Planning Commission Regular Meeting

Monday, January 26, 2026, 6:30 PM
106 Center Street

ADDITION & REMODELING FOR:
BENNETT RESIDENCE
150 BELL STREET
EXCELSIOR, MN

1 FRONT ELEVATION
2 SCALE: 1/4" = 1'-0"

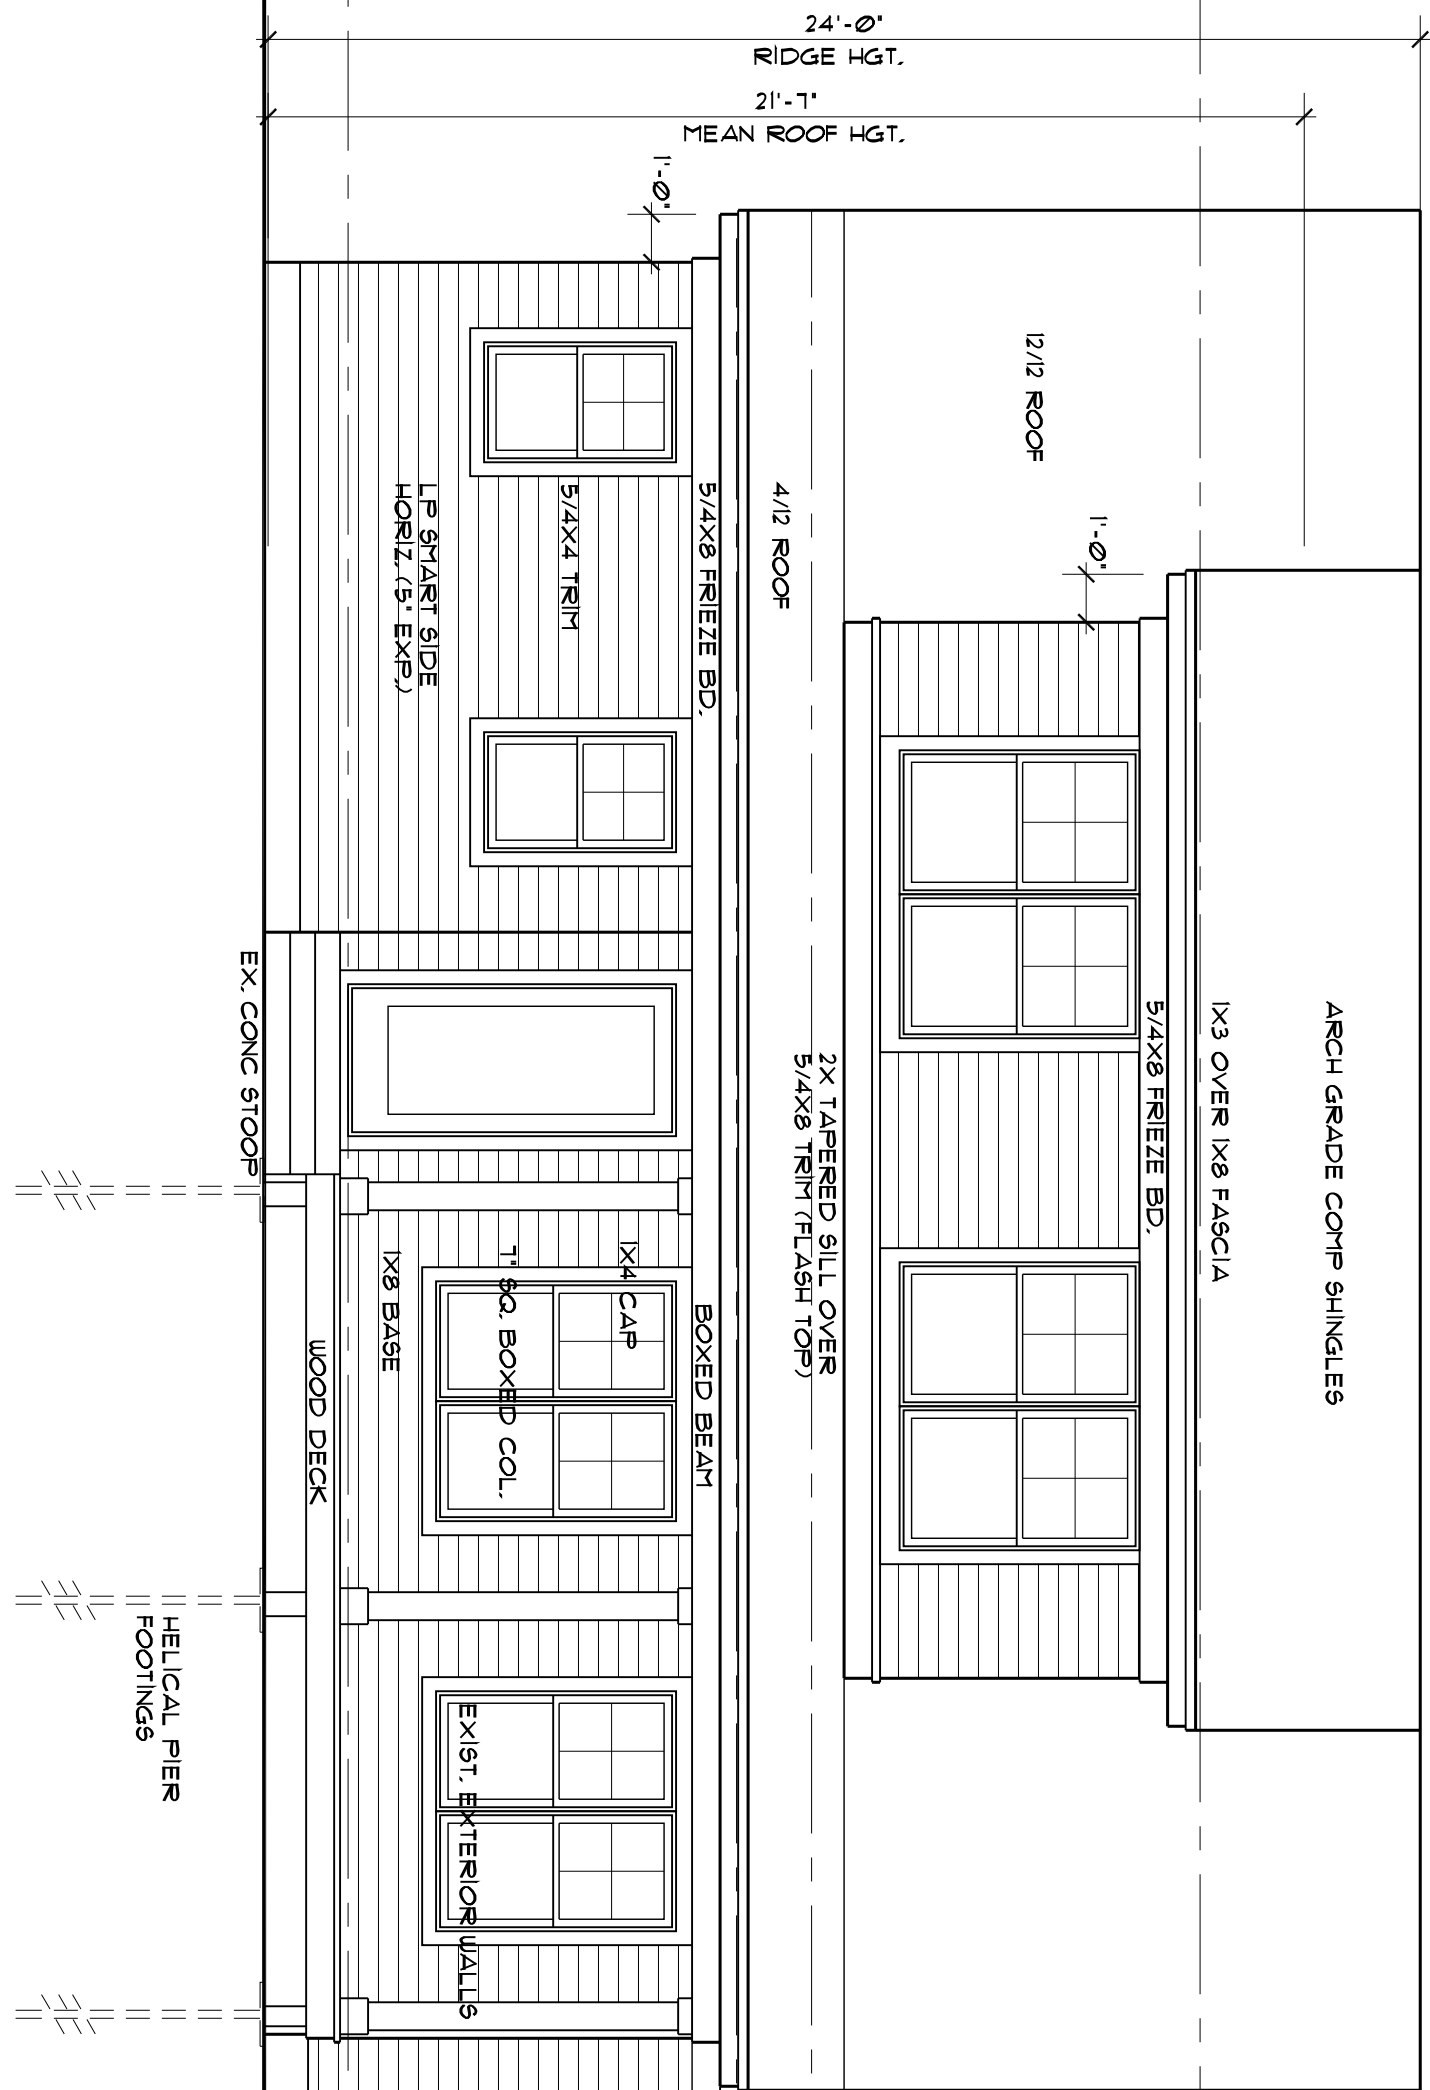
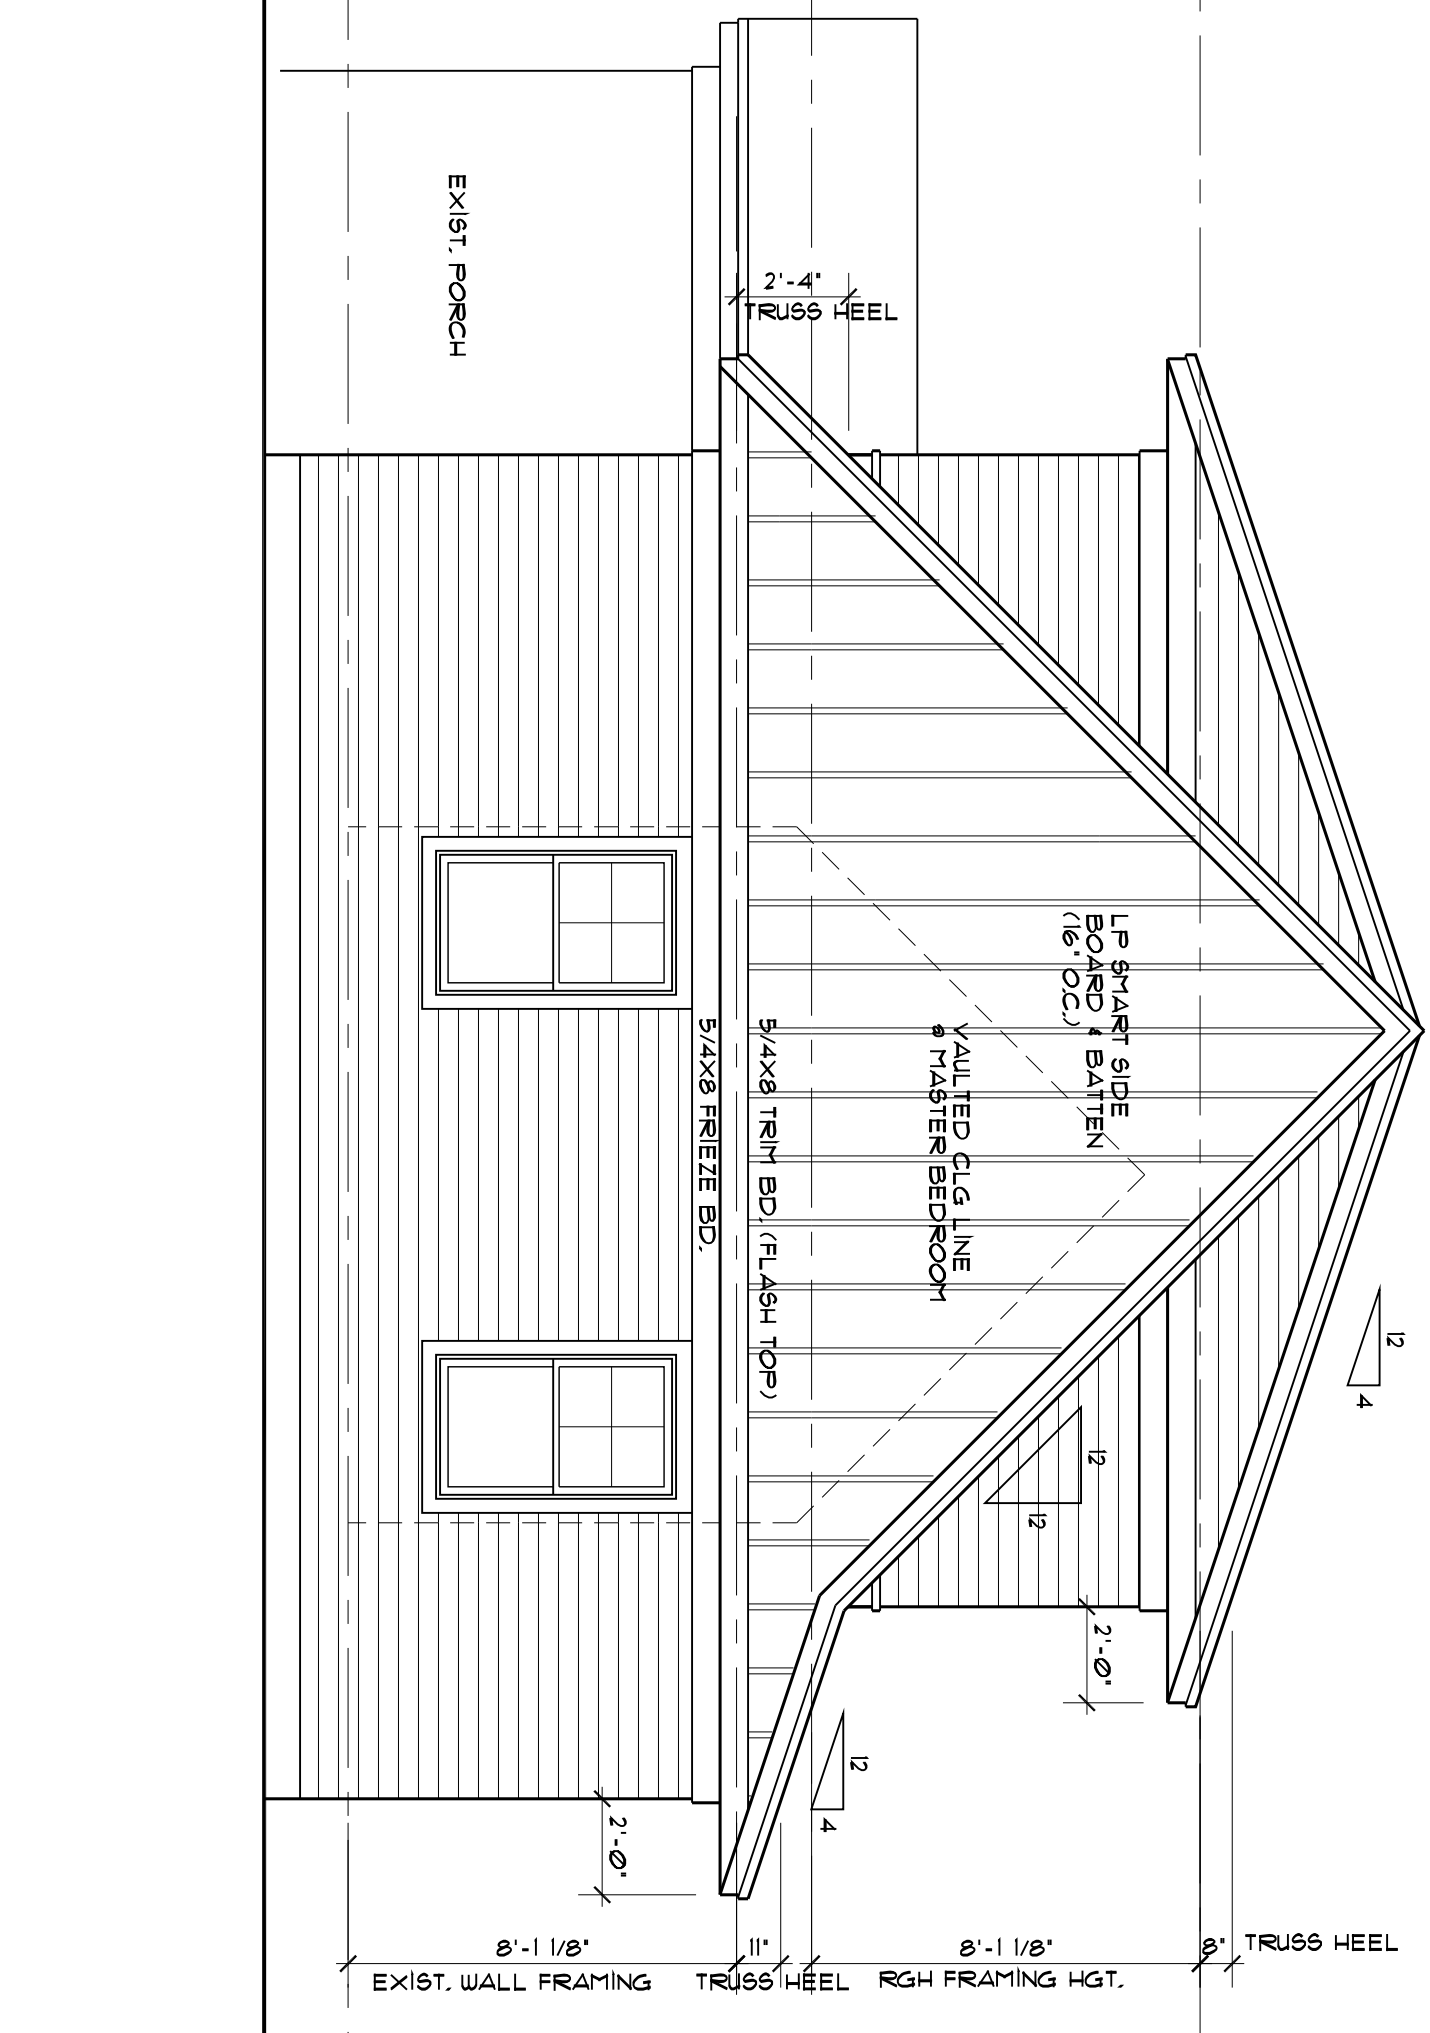
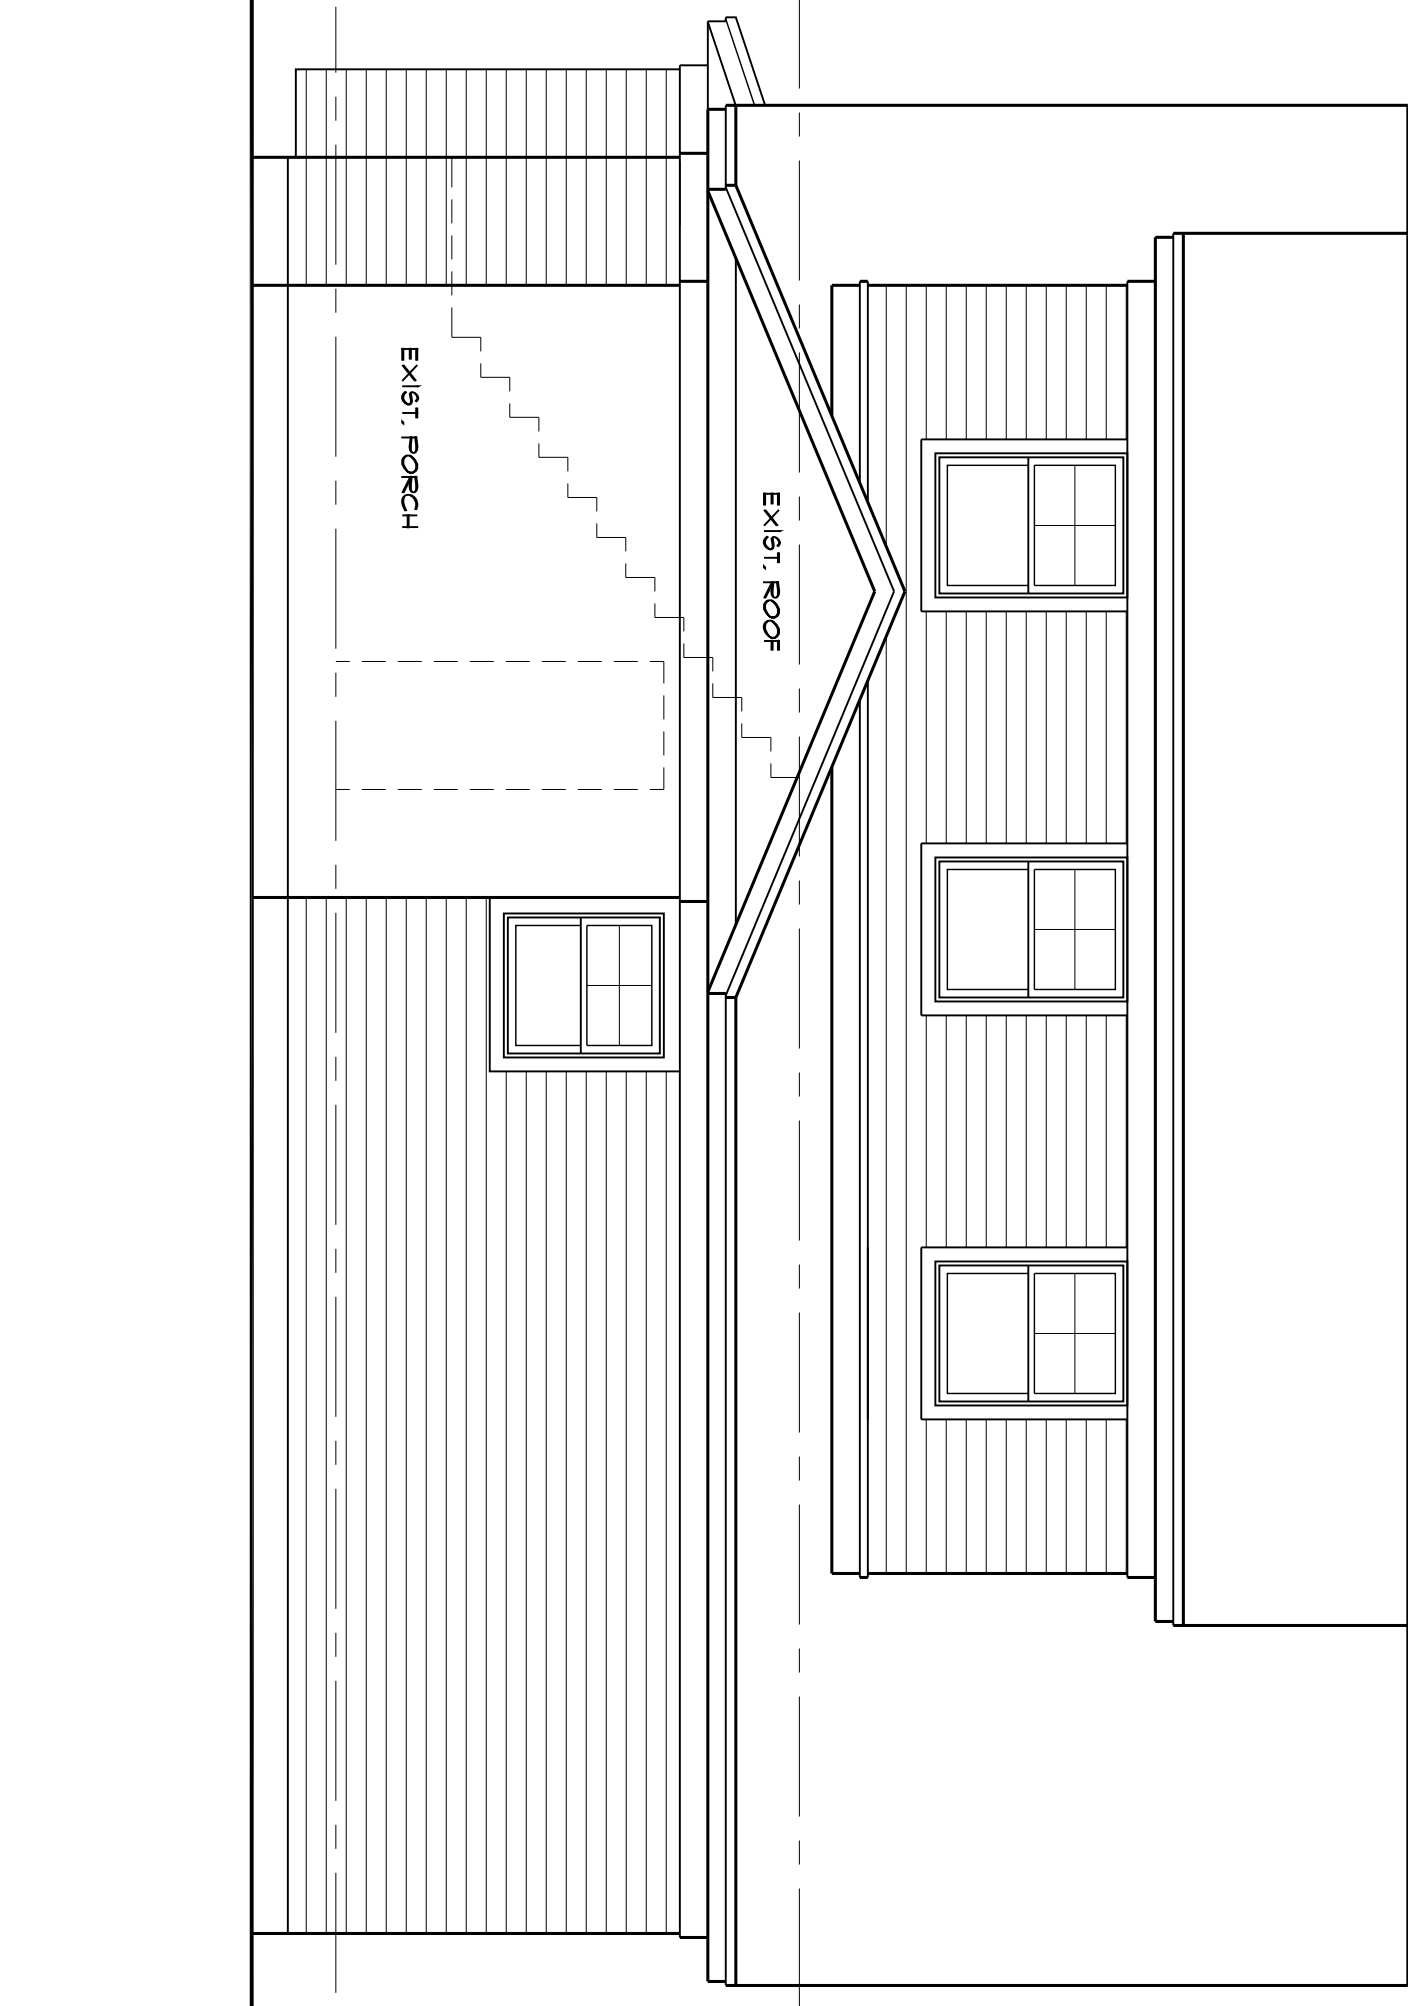
Generally, the height, massing and scale of the proposed house second level addition seem compatible with neighborhood context. By keeping the second story plan space smaller than the first, the shed dormer roof forms are inset from the ends enough to give an appearance of a 1-1/2 story massing that seems compatible with neighboring structures.
